**Lufttüchtigkeitsanweisung (LTA)
Nr. 2024-001**

Prime BS100

Service Bulletin No.	BPU-SB-2024-02
Rev.	1
Date Issued	03/05/2024
ATA Code	5
Page	1 of 7

Title: Measures for preventing Fuel Tank overpressure

Figure 1 – Bonding lines (the dotted line refers to the bonding line of the lower skin to the forward spar)

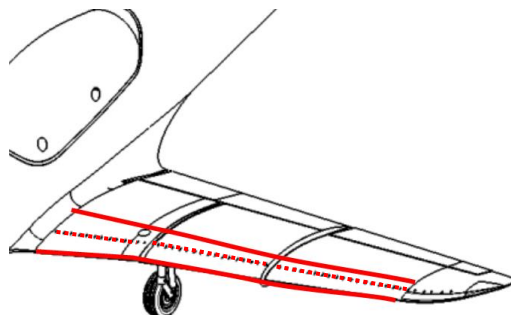
1. Perform visual inspection on the external surface of LH and RH wings, checking along the bonding lines of the wing skin to the forward spar and on the leading edge of the wing, in correspondence of the bonding line between upper and lower skins, for presence of deformations, cracks, or any other signs of damages of the external surface. See Figure 1 for the identification of the bonding lines.

2. In case of deformations, cracks, or any other signs of damages of the external surface, stop any flying activity and contact aftersales:
aftersales@blackshapeaircraft.com

Figure 2 – Wing inspection door.

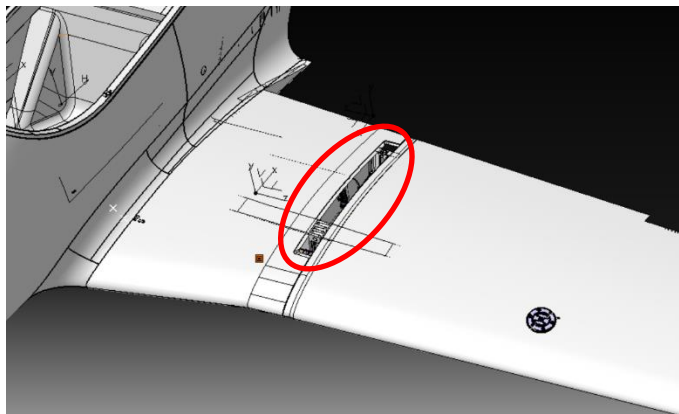
1. Remove wing inspection door highlighted in Figure 2

Figure 3 – Rollover valve position in wing inspection door.

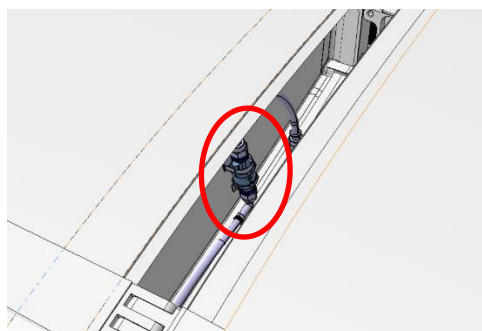
2. Uninstall the rollover valve seated in the wing inspection door (see Figure 3) by unscrewing the 90° fittings [1] see Figure 4

Figure 4 – Rollover valve installation.

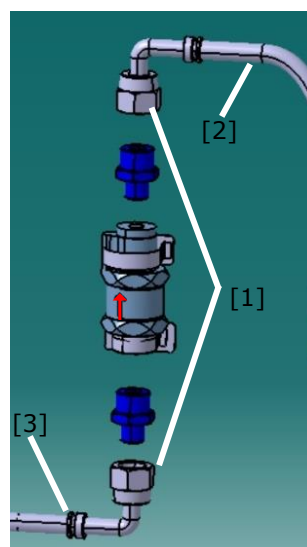
- a. the rollover valve in both flow directions keeping the valve in the vertical orientation with the arrow (see Figure 4) pointing upwards and then pointing downwards.
- b. the tube from the rollover valve to the vent port ([2] in Figure 4) checking that the air goes out through the vent port.
- c. the tube from the rollover valve to the fuel tank ([3] in Figure 4) checking that the air goes out through the fuel filler cap hole.

Figure 5 – Fuel filler cap small opening.

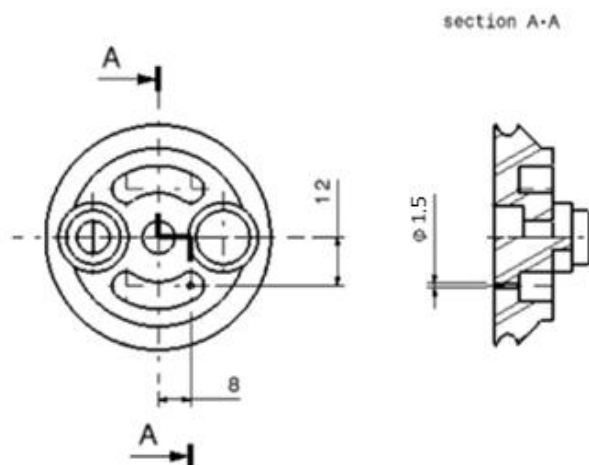
The reworking performed by Blackshape consists in making a small opening of 1.5mm onto the fuel filler cap as specified in Figure 5.

1. Send both fuel filler caps to Blackshape ⁽¹⁾ for reworking.
